**STATE OF KANSAS  
BEFORE THE DIVISION OF WATER RESOURCES  
KANSAS DEPARTMENT OF AGRICULTURE**

**Case No. 18 WATER 14014**

**Expert Report by Tim Boese  
for  
Equus Beds Groundwater Management District No. 2**

The City submitted to the Chief Engineer a proposal titled "ASR Permit Modification Proposal Revised Minimum Index Levels & Aquifer Maintenance Credits" (Proposal). The Proposal included a cover letter dated March 12, 2018, and also included supporting information. The Proposal requested that the following changes be made to the ASR Phase II approved water permits and also be applied to any pending or future ASR water permits:

**Figure 4 Copy of Figure 40 of the USGS Report: Simulated and observed groundwater levels for selected wells**

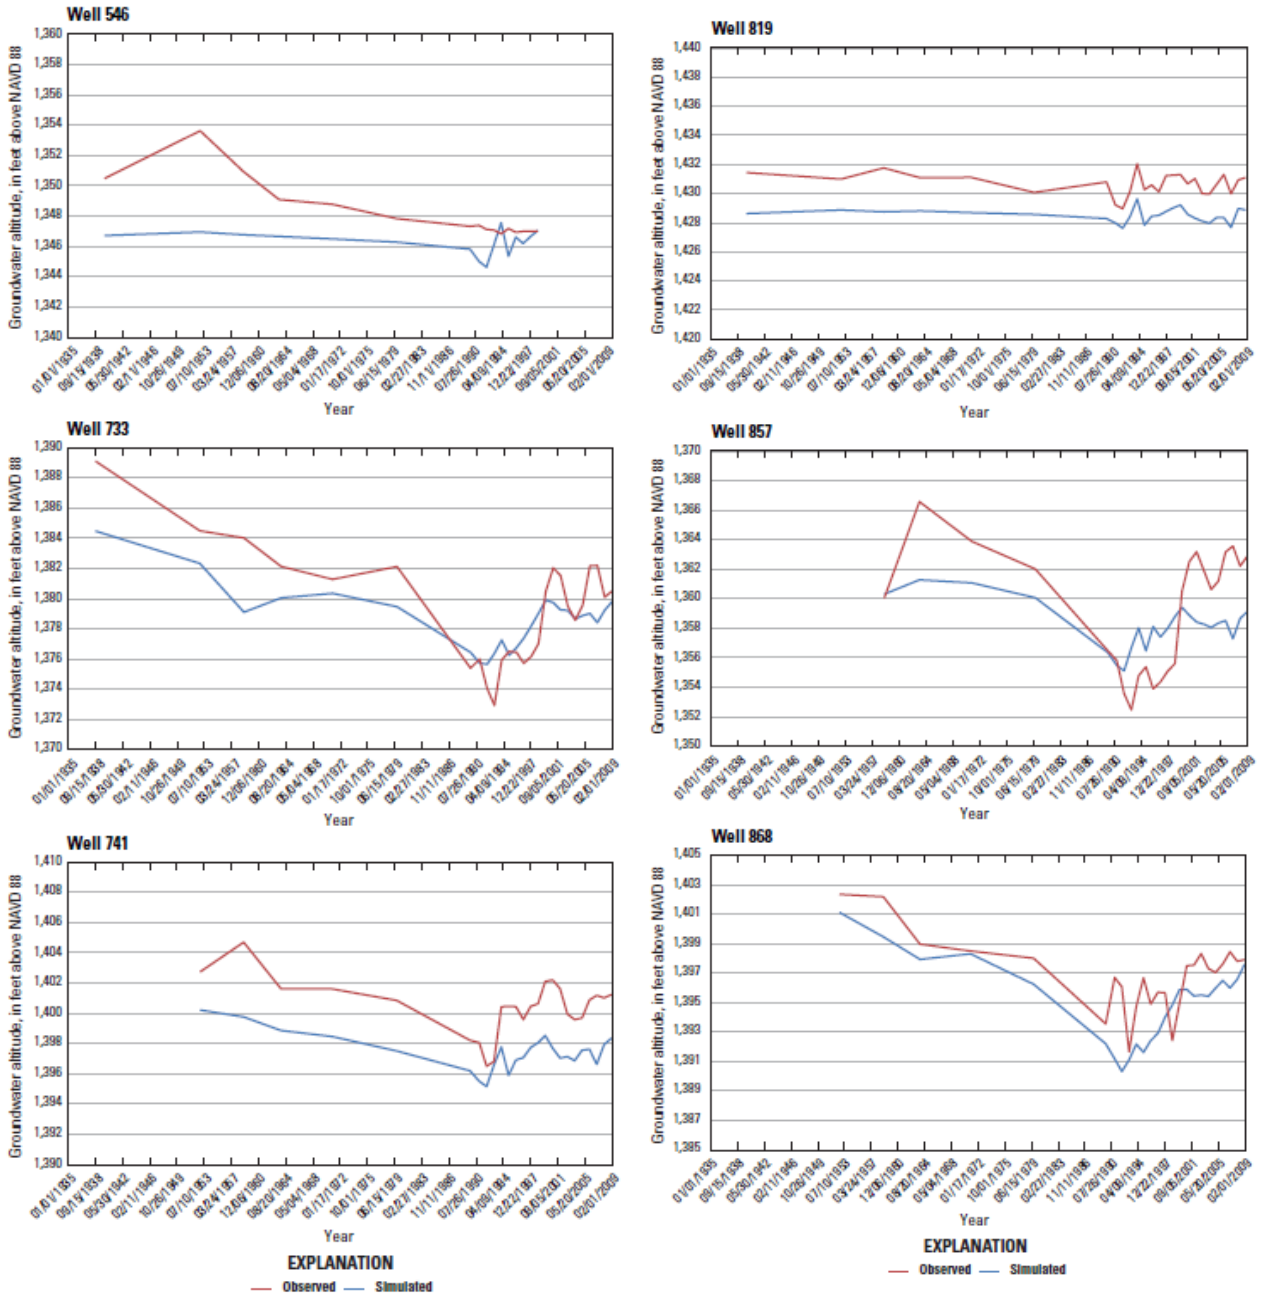
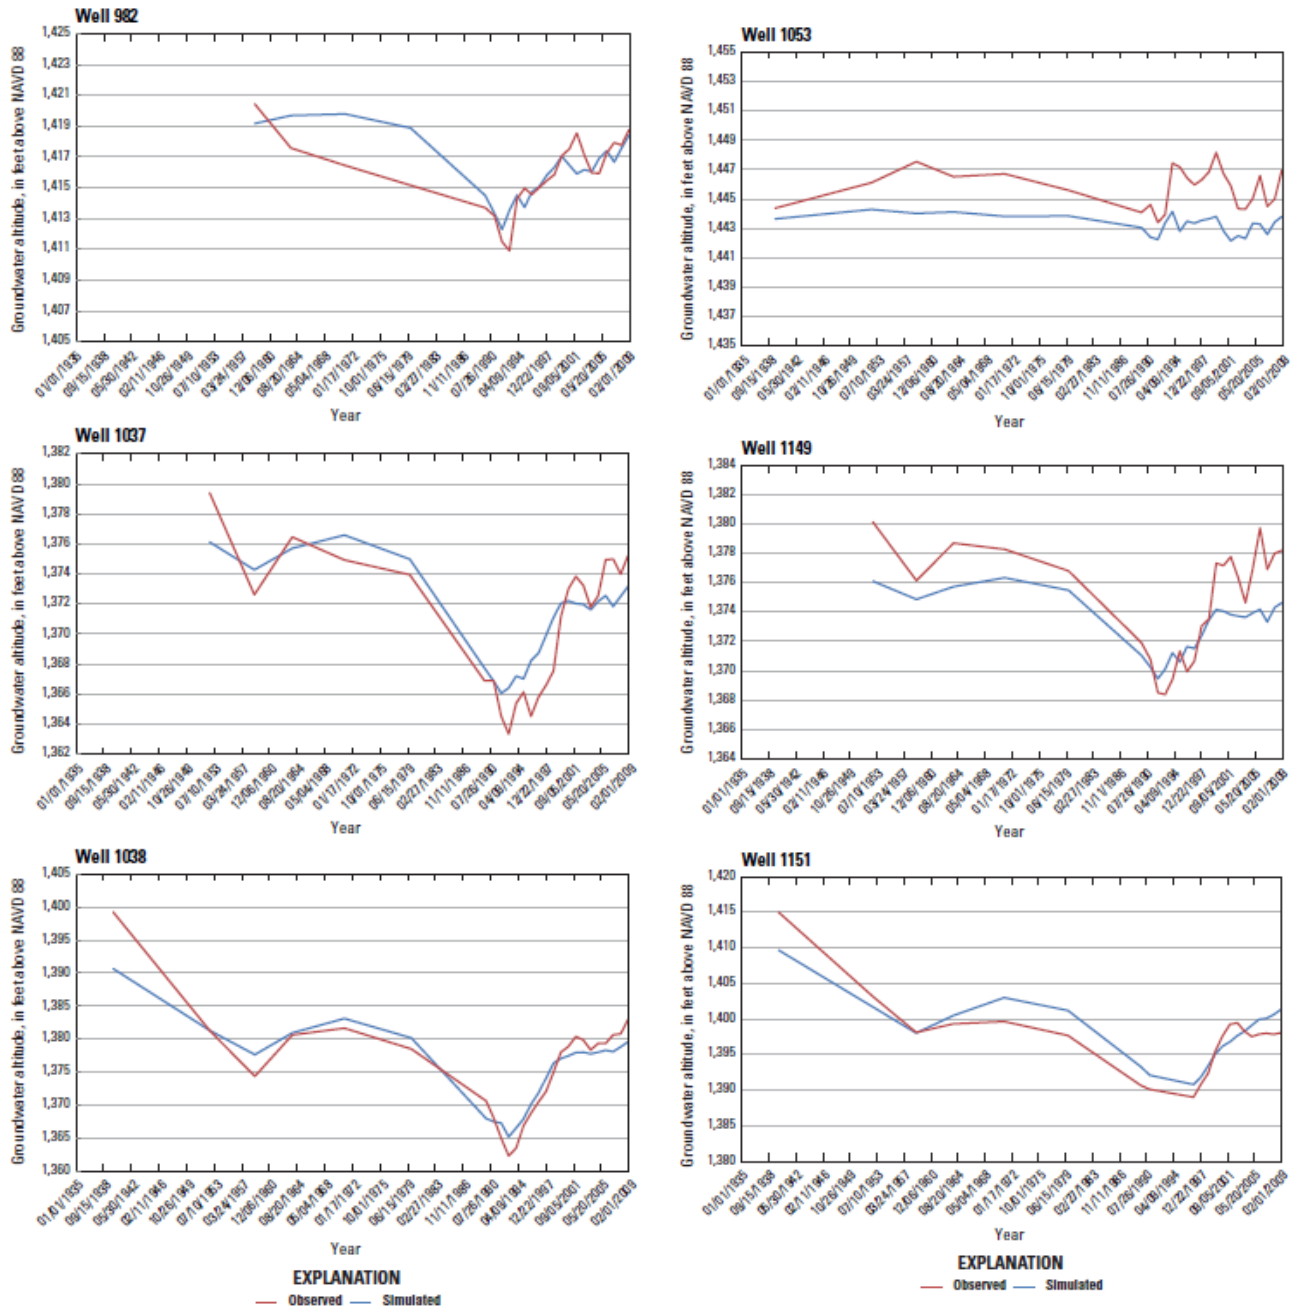
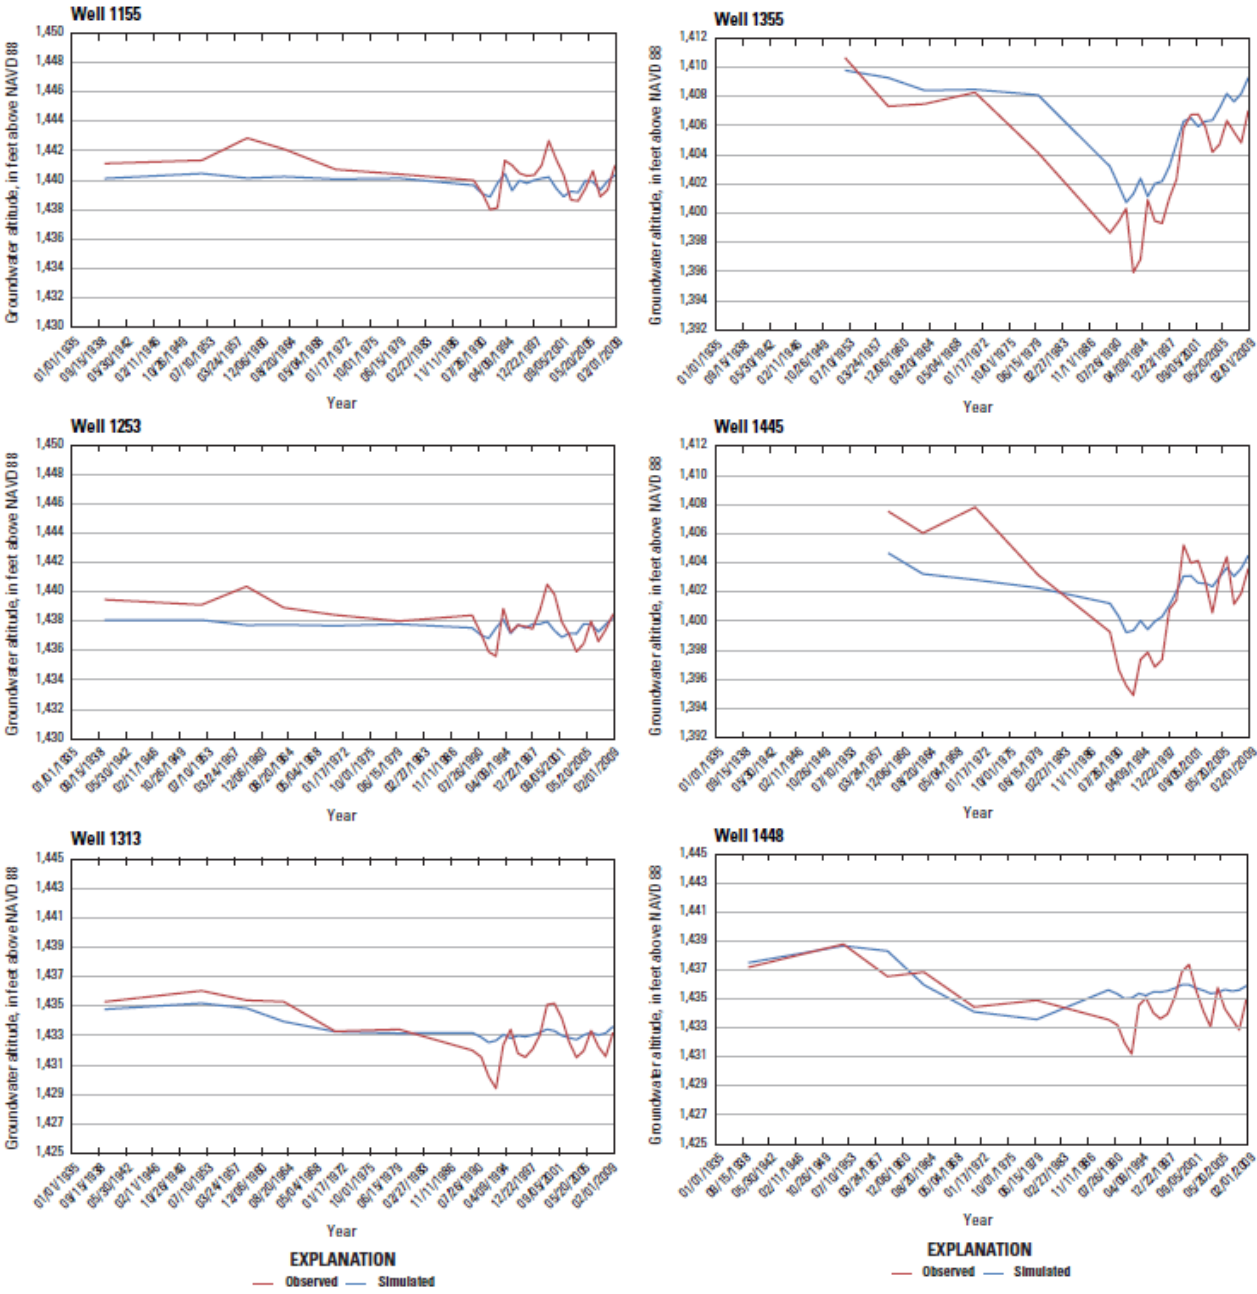
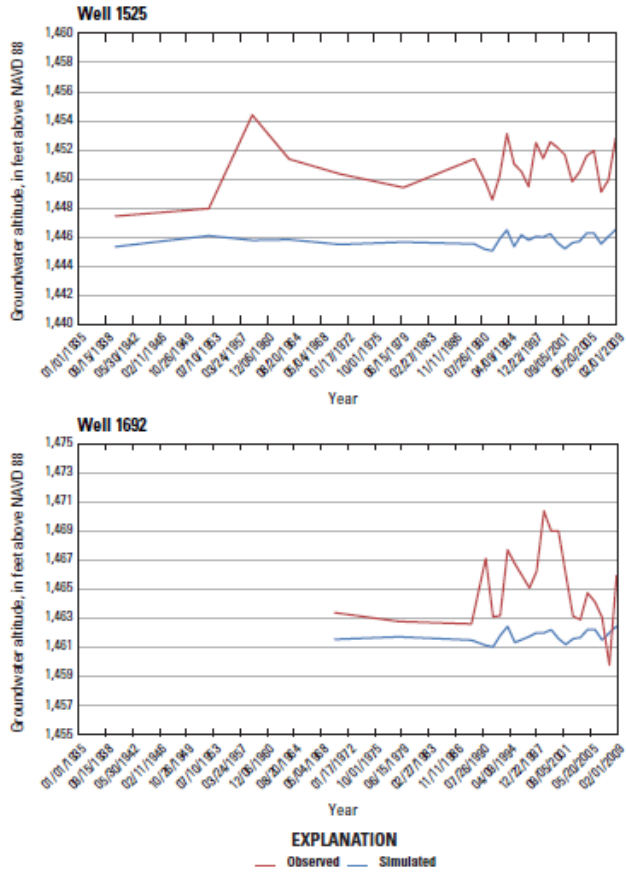
19. **Figure 4** provides a copy of Figure 40 of the USGS report, illustrating simulated versus observed groundwater levels in the selected monitoring wells. As depicted in this figure, the model tends to underestimate groundwater levels in the majority of these monitoring wells. For further analysis of these graphs, I downloaded the simulated and observed water levels in selected monitoring wells from Table 9 of the USGS report, listed on Page 89 of this report, and provided a summary of my analysis in **Table 3**. According to this table:

26. The model tends to underestimate groundwater levels in 60% of the monitoring wells selected by USGS to show the acceptability of model results. The underestimations are prevalent specially during drought periods. However, minimum drought model elevations have been considered to propose modified ASR Minimum Index Levels for over half of the Index Wells.

Figure 5 Copy of Figure 41 of the USGS Report: Observed and simulated cumulative streamflow gains and losses for the Arkansas and Little Arkansas Rivers for the transient simulation

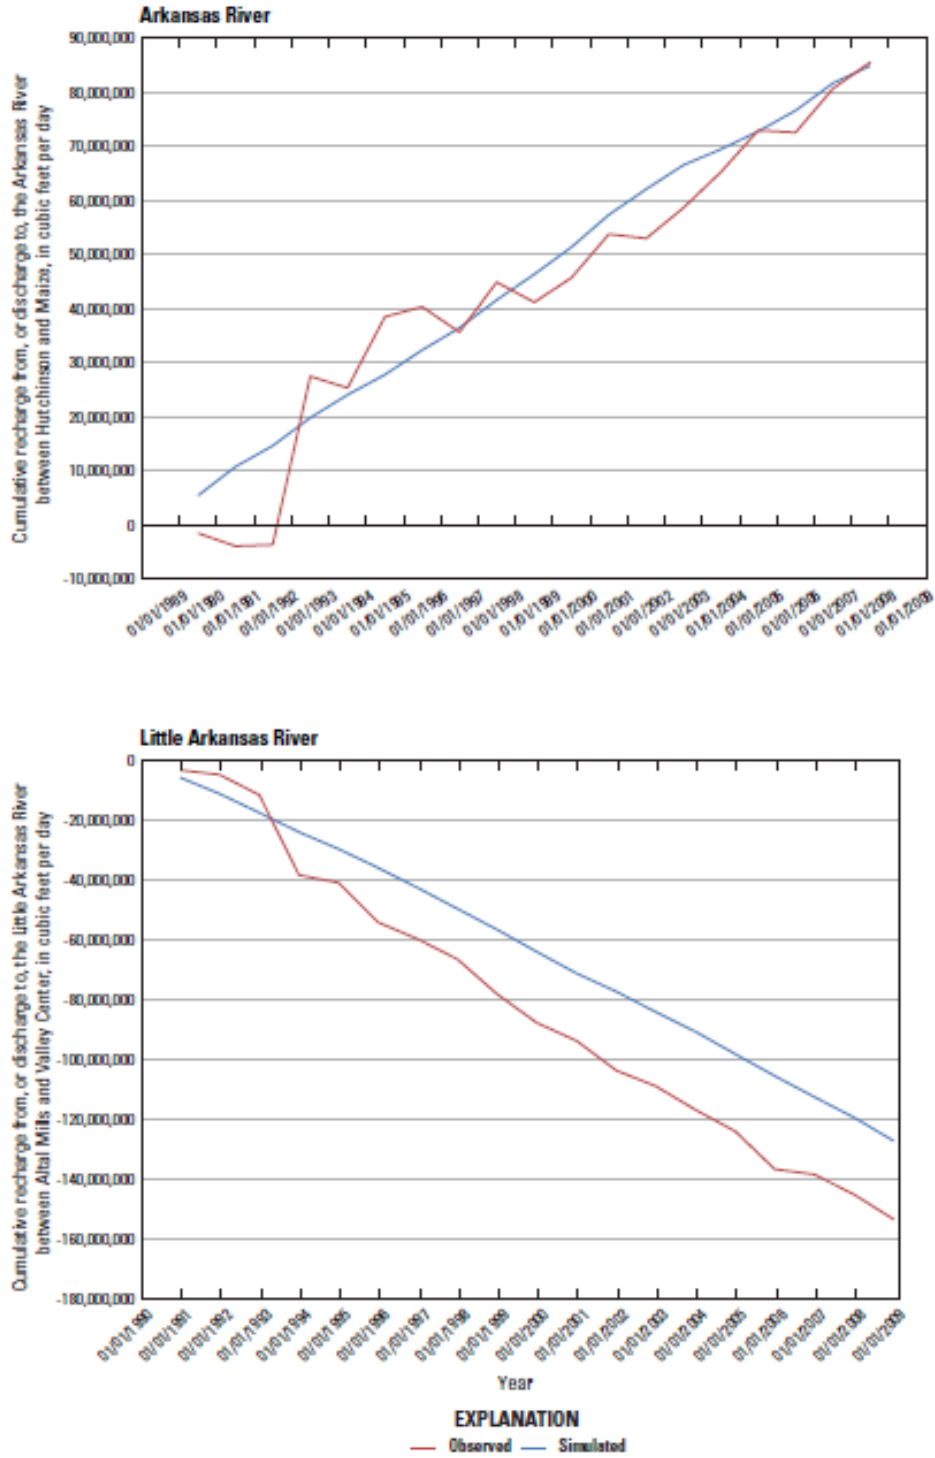
20. Page 53 of the USGS report states that “*Cumulative streamflow gain and loss observations are similar to the cumulative simulated equivalents and are shown for the Arkansas River and Little Arkansas River in figure 41*”. While simulated cumulative streamflow gains and losses in the Arkansas River show a good match with the observed data, based on Figure 41 of this report, these cumulative simulations for the Little Arkansas River overestimate observations by approximately 17%. A copy of this figure is provided at the end of this report (**Figure 5**).

**FIGURE 1**  
**HYDROLOGIC SYSTEM RESPONSE TO CITY PUMPING ASR RECHARGE CREDIT**

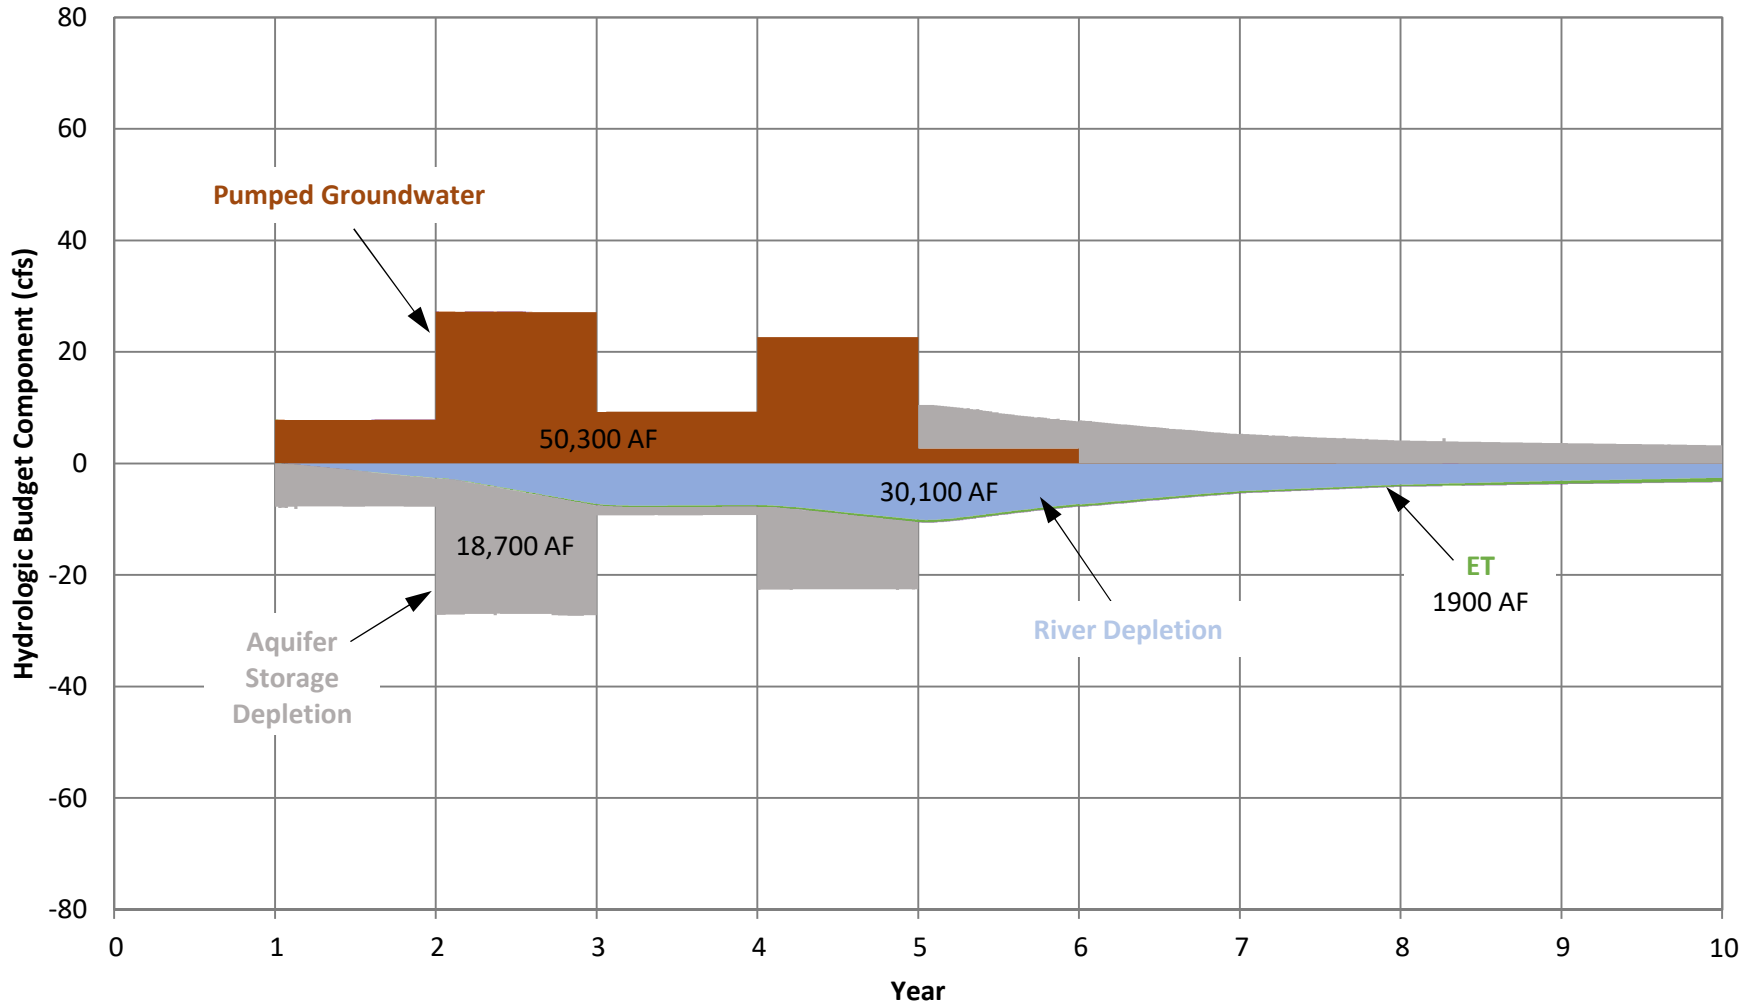
72 The BMcD analysis in the Proposal presents results of the 1% drought simulation in the  
73 context of water-level elevations and percent of saturated thickness of the aquifer. The results are  
74 based on the total City pumping (non-credit and ASR recharge credit) represented in the 1% drought  
75 simulation (Burns & McDonnell, 2018a, Table 2-5). The model has the capability of isolating  
76 hydrologic effects from components of City pumping. For example, the BMcD 1% drought analysis  
77 can be adapted to quantify the hydrologic effect of pumping the ASR recharge credit. **Figure 1**  
78 shows how the hydrologic system responds to City ASR recharge credit pumping in the 1% drought  
79 simulation. Initially, the pumping produces most of the water from aquifer storage, but as pumping  
80 continues, the cone of depression from groundwater pumping induces (depletes) flow from the Little  
81 Arkansas and Arkansas rivers. A notable observation on **Figure 1** is that stream depletion continues

82 to occur for years after groundwater pumping ceases. This lagged depletion response occurs  
83 because, even though pumping has stopped, stream depletion continues to fill in the cone of  
84 depression that was caused when the well was pumping.

**FIGURE 4**  
**HYDROLOGIC SYSTEM RESPONSE TO CITY PUMPING PROPOSED ASR RECHARGE CREDIT (SCENARIO C)**

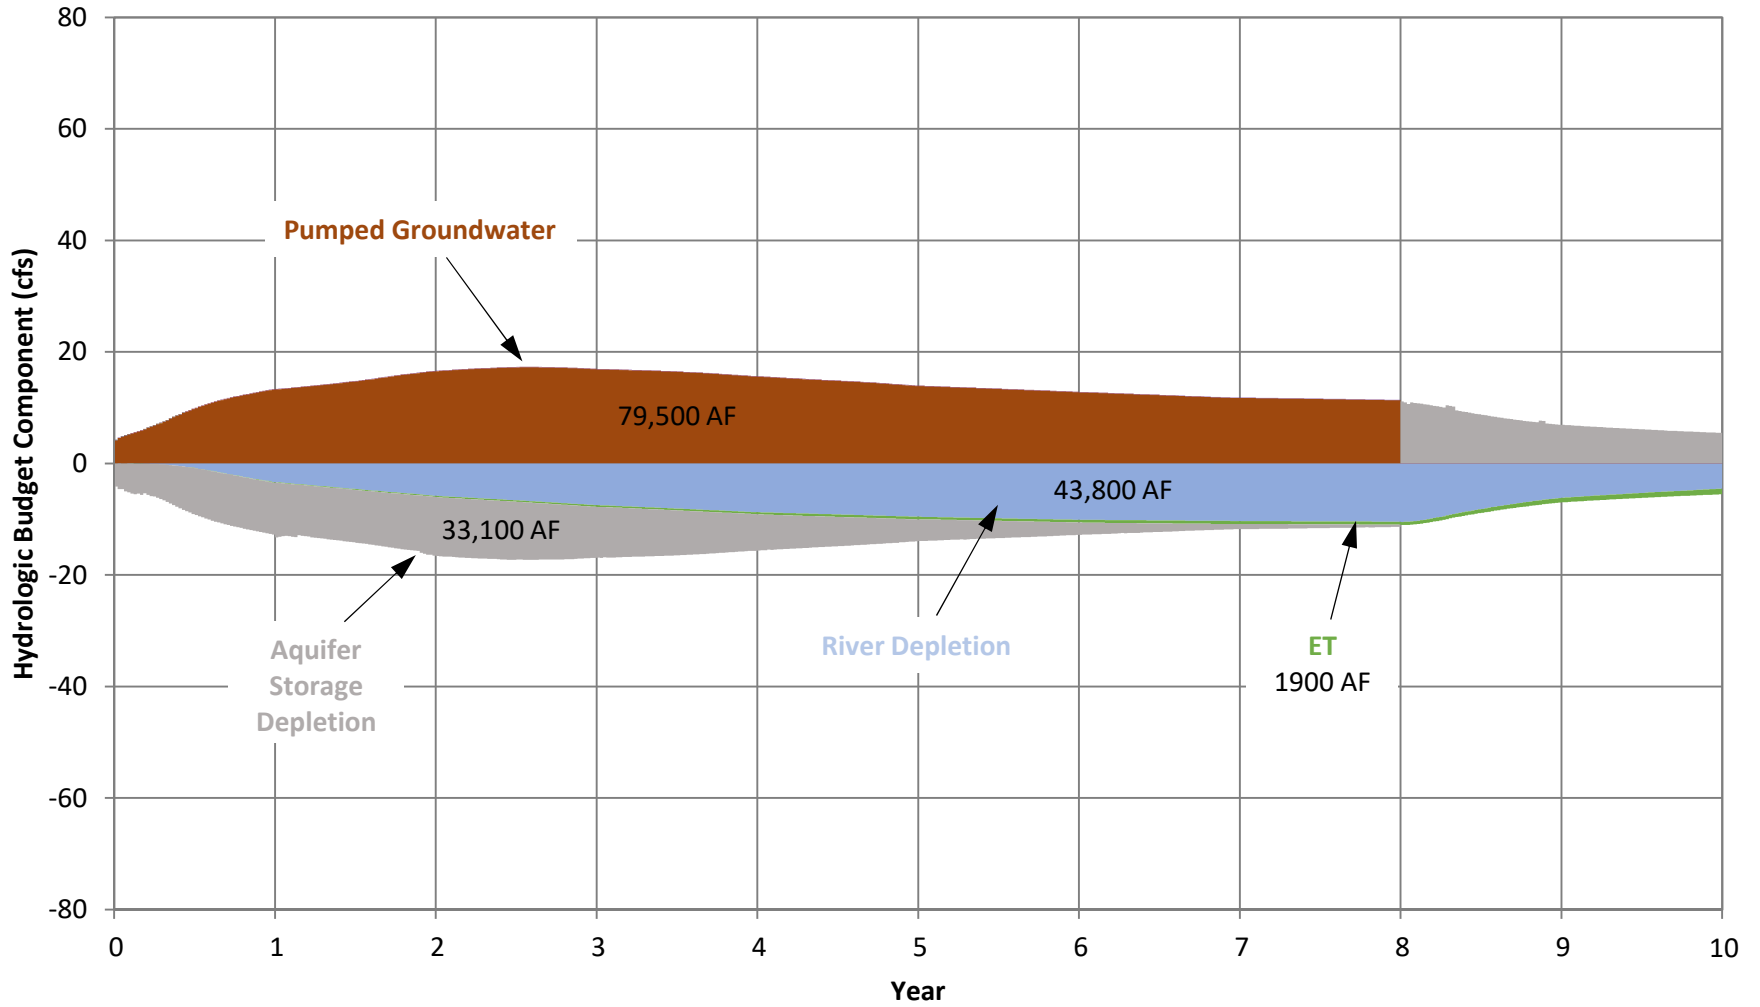
155 drawdown from City pumping occurred to the level of the proposed minimum index level. **Figure 4**  
156 shows the hydrologic system response to that diversion and indicates the amount of ASR recharge  
157 credit water that could produced is 79,500 acre feet, which is in addition to the 14,900 acre feet  
158 produced in Scenario B.
